CITY OF PORT WENTWORTH

PLANNING COMMISSION

JUNE 11, 2018

Site Plan Review Application submitted by Haydon Rollins, Hussey, Gay, & Bell, on behalf of CRN Development, LLC., for PIN # 7-0037-01-012 (Coldbrook Station Cir) for a Specific Development Site Plan to allow a multi-family apartment development in a P-R-M (Planned Residential Multi-Family) Zoning District

DRAWING NUMBER
09
 OF 28

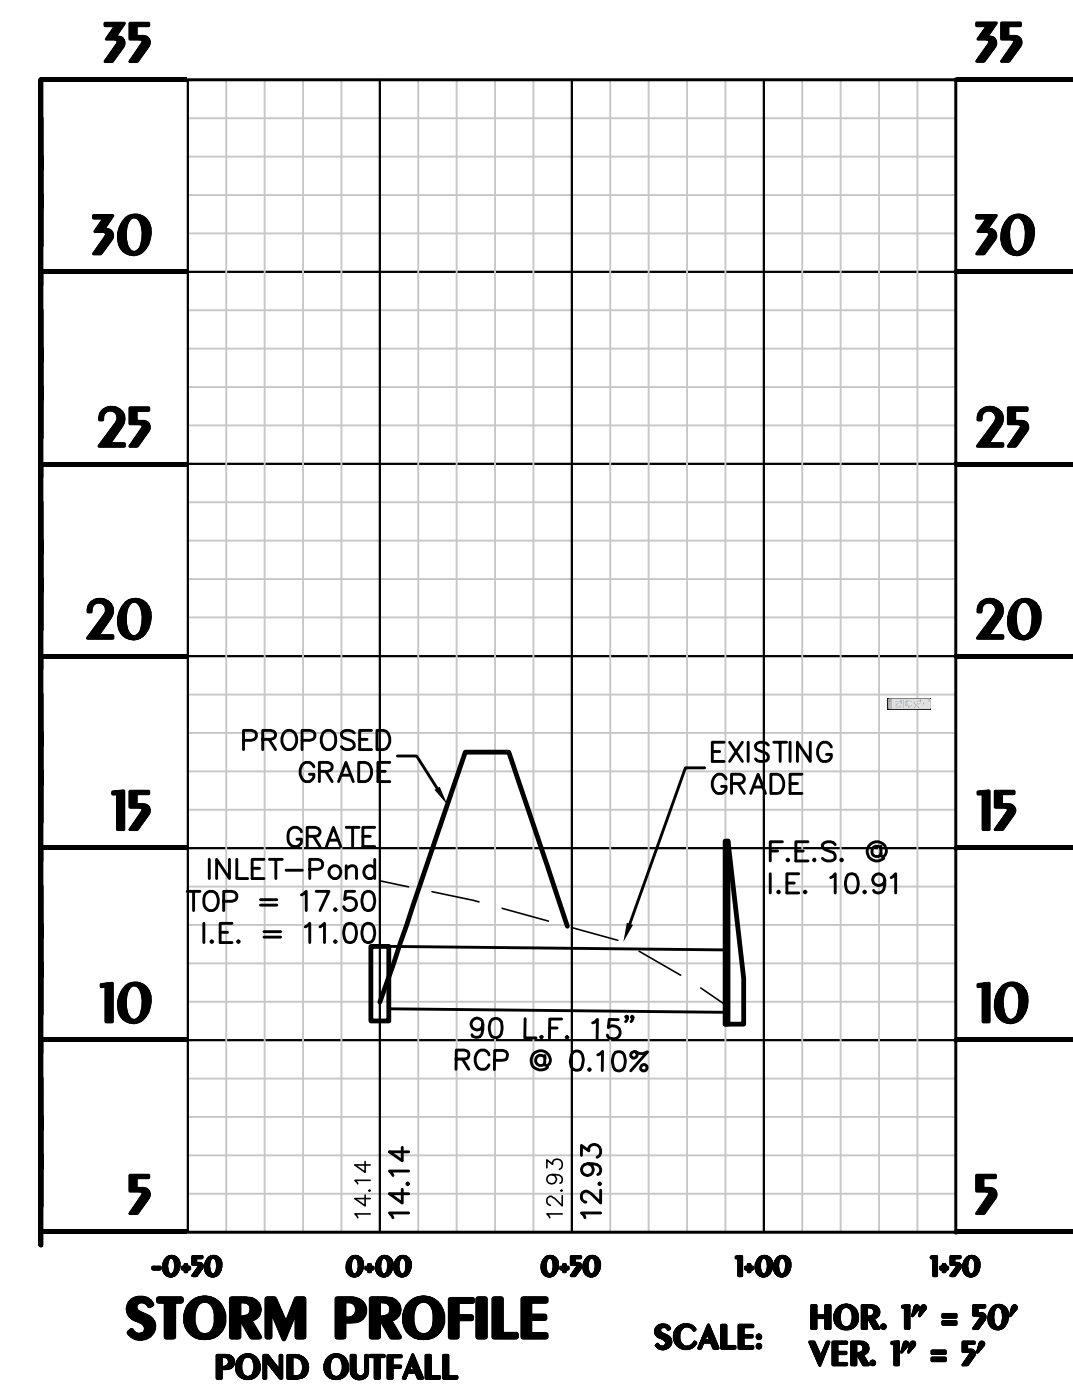
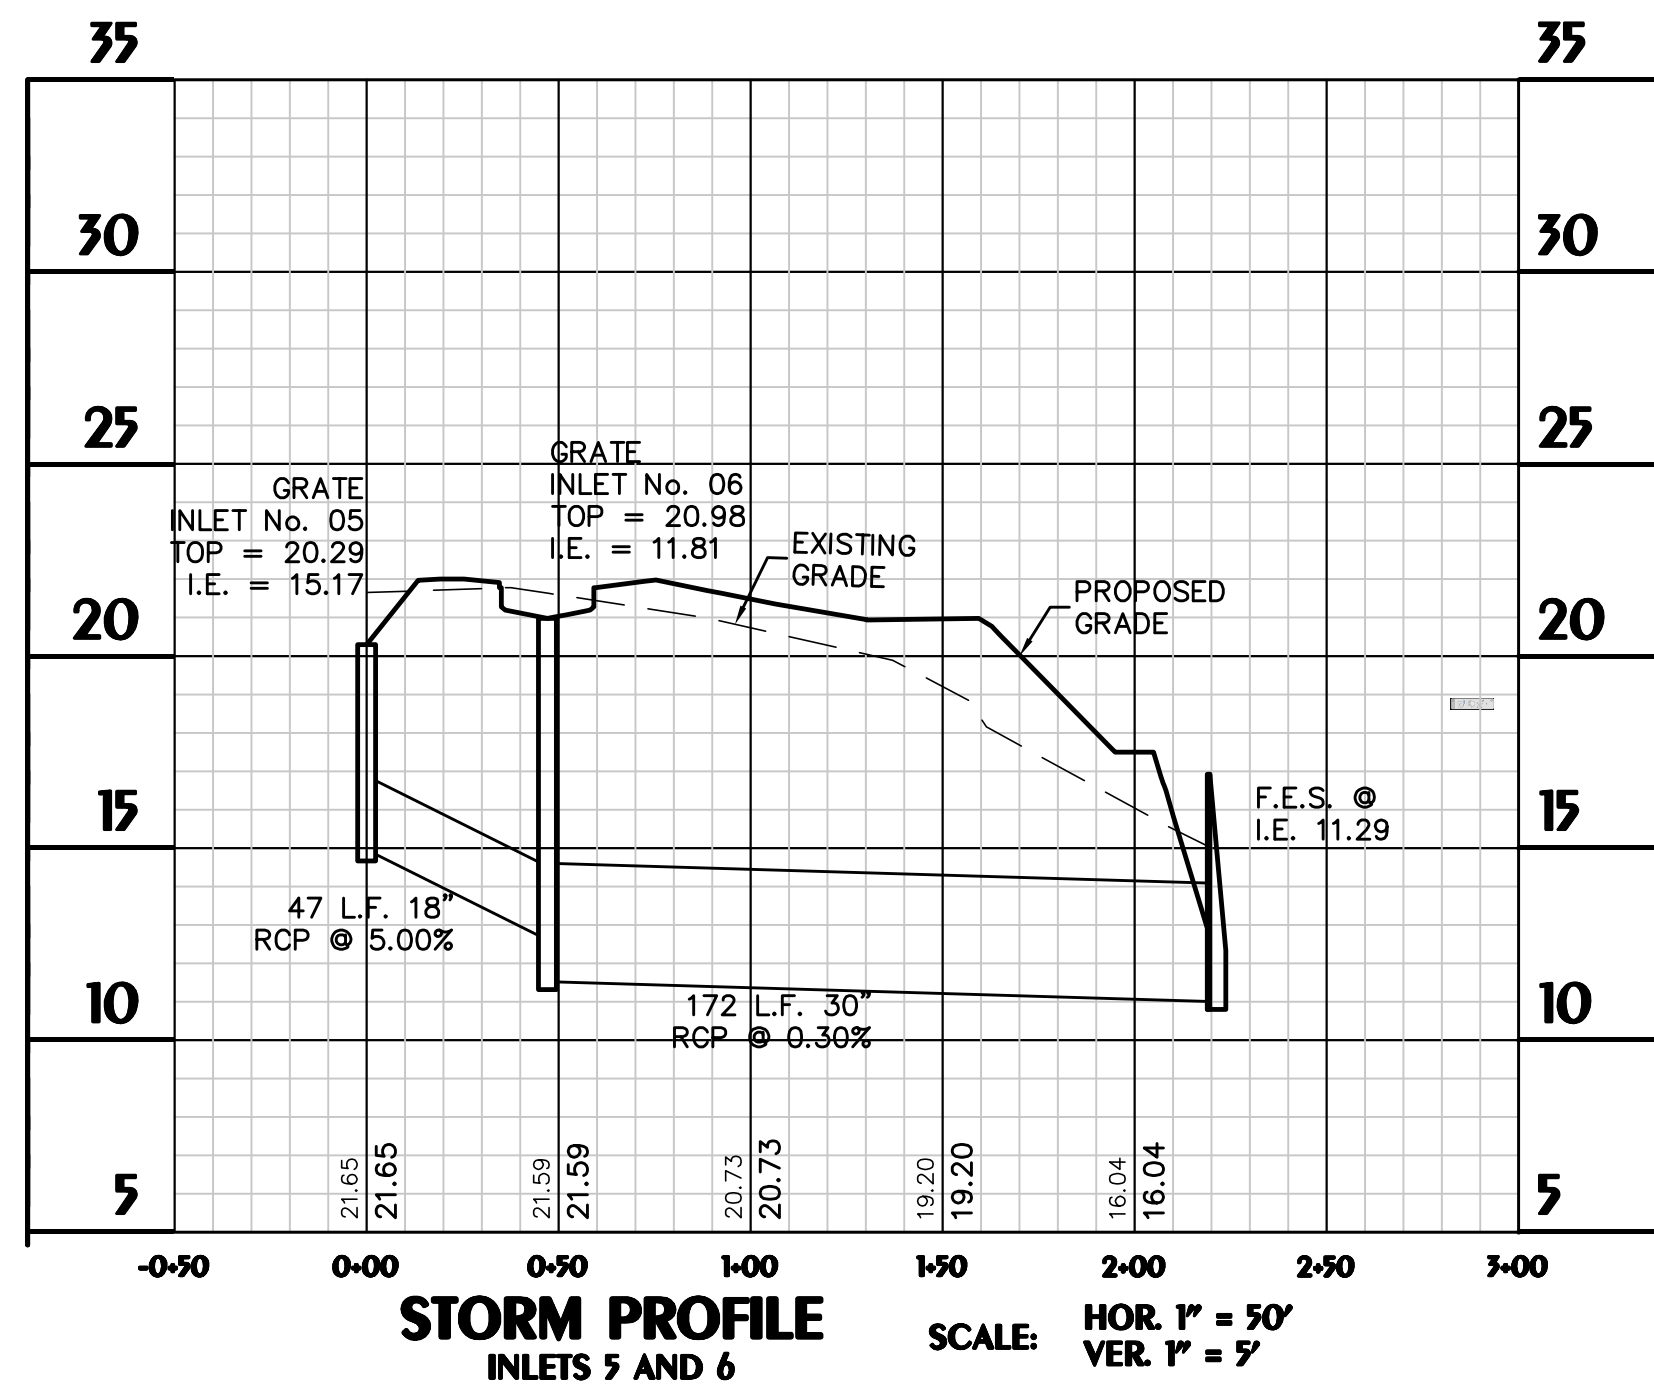
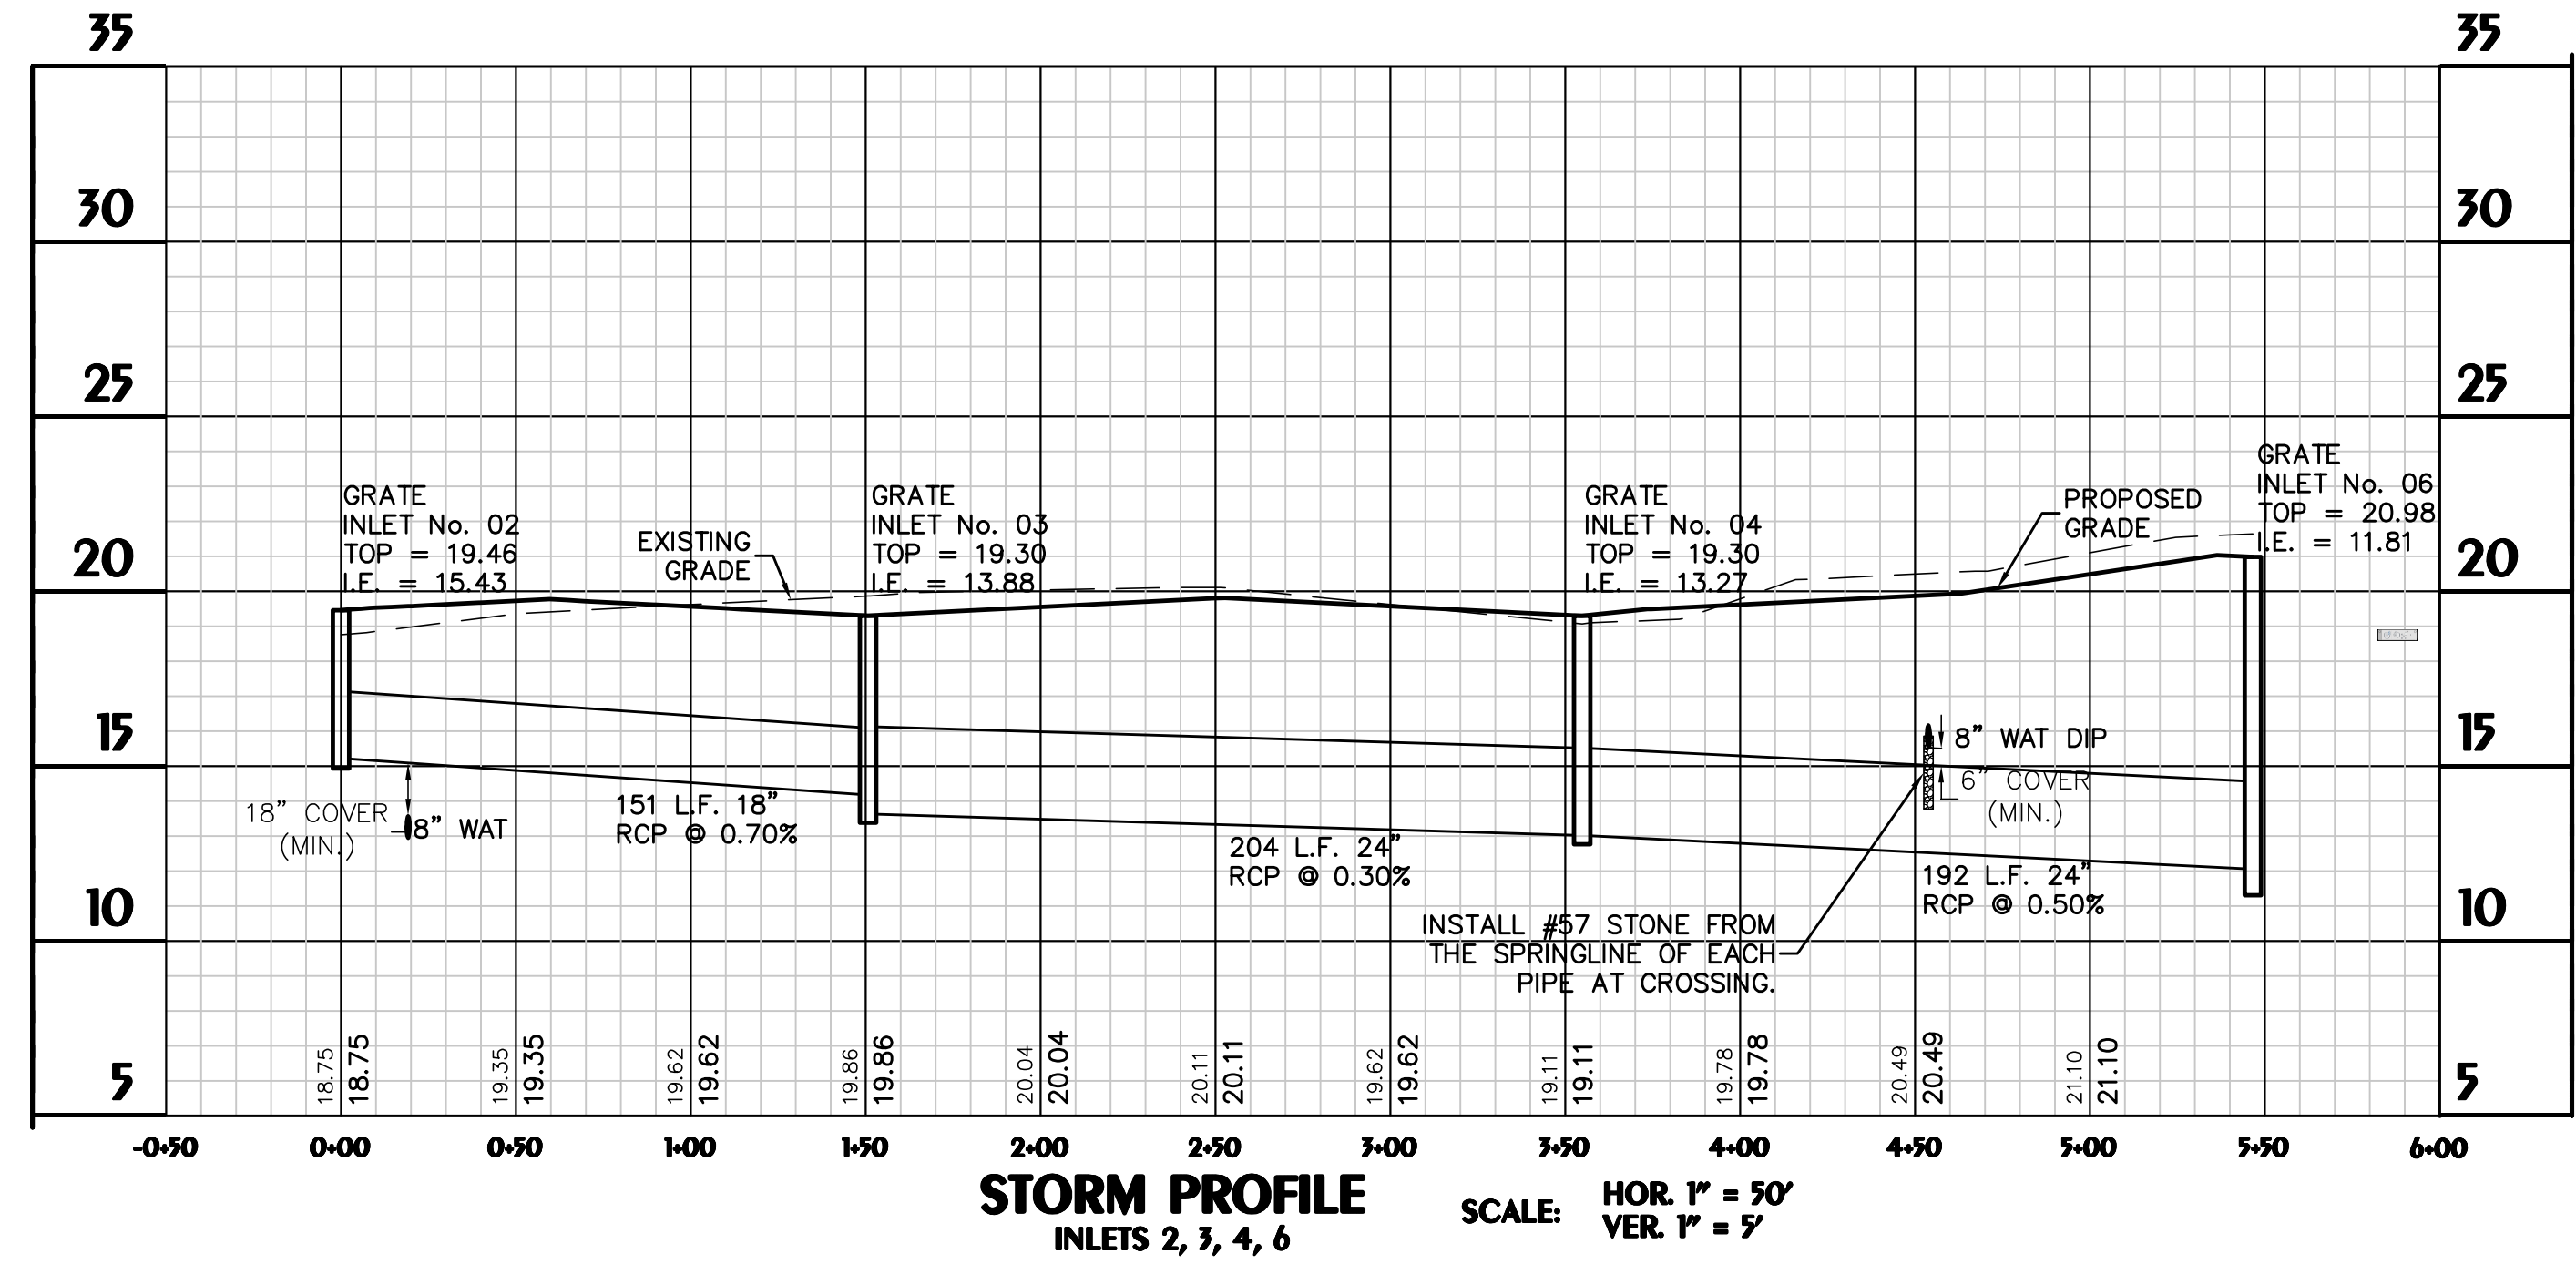
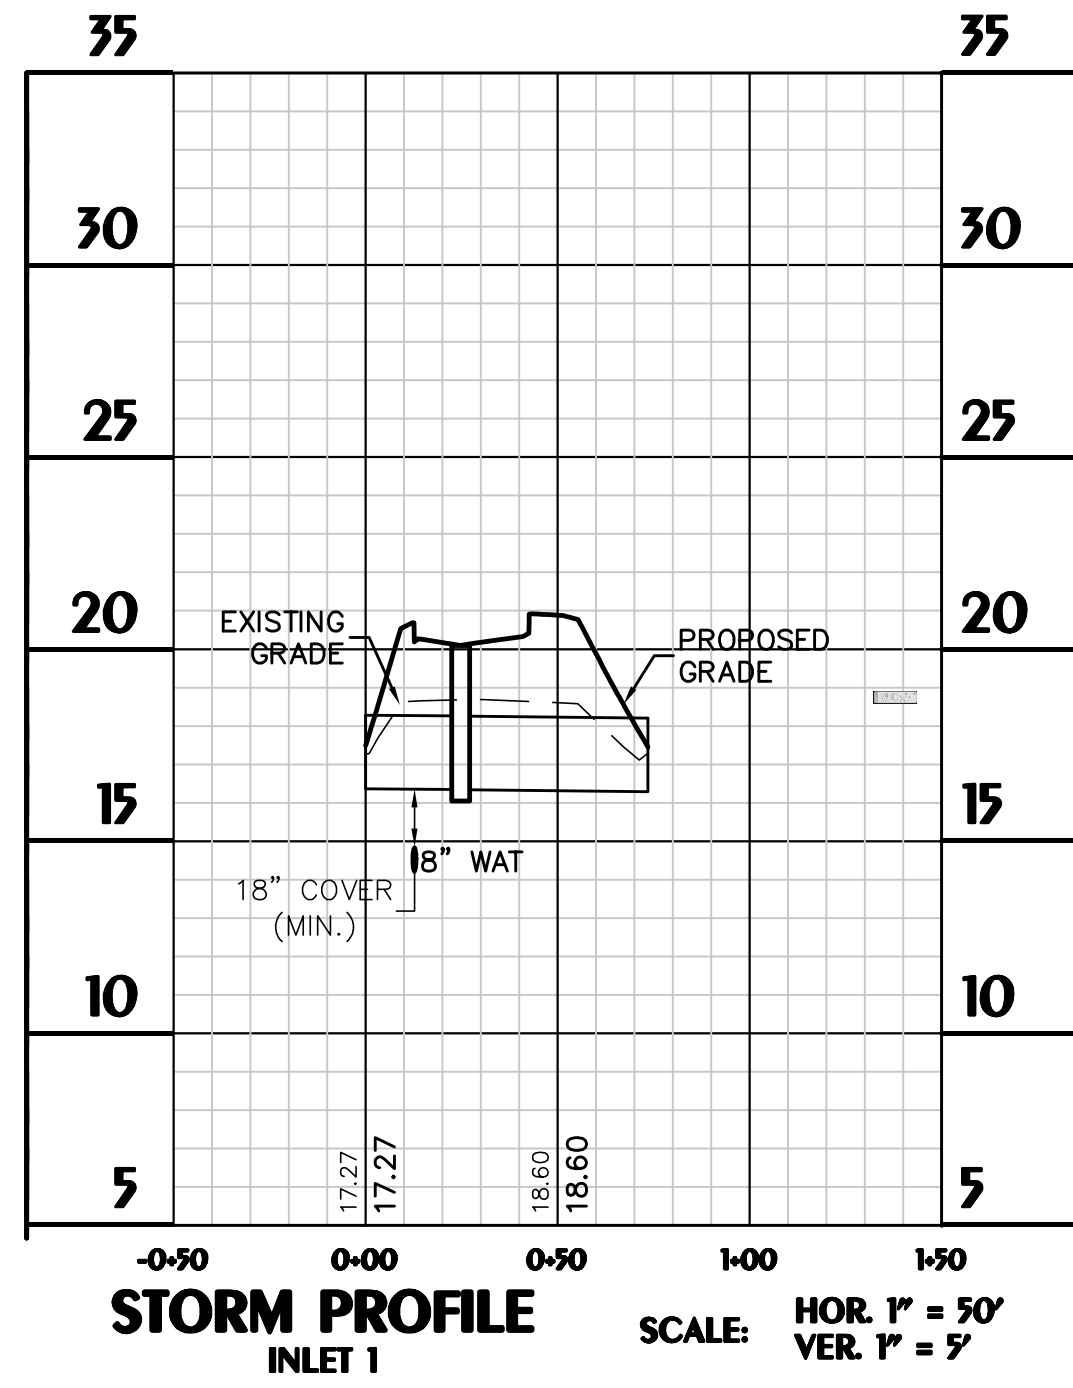
18. Provide storm drain profiles showing water or sewer crossings.
Acknowledged. Please see the revised plan sheet 9.
19. Add Pre vs. Post Development Detention Analysis for the 2-Year & 5-Year events to the Hydrology Report. *Acknowledged. Please see the revised hydrology report.*

9. Add back the water service manifold detail and provide backflow protection.
Acknowledged. Please see the revised plan sheet 11.
10. The 8" DIP water line downstream of Grade Inlet #4 shall have #57 stone placed between the intersection of the Mo pipes from the spring line of each pipe. *Acknowledged. Please see the revised plan sheet 9.*
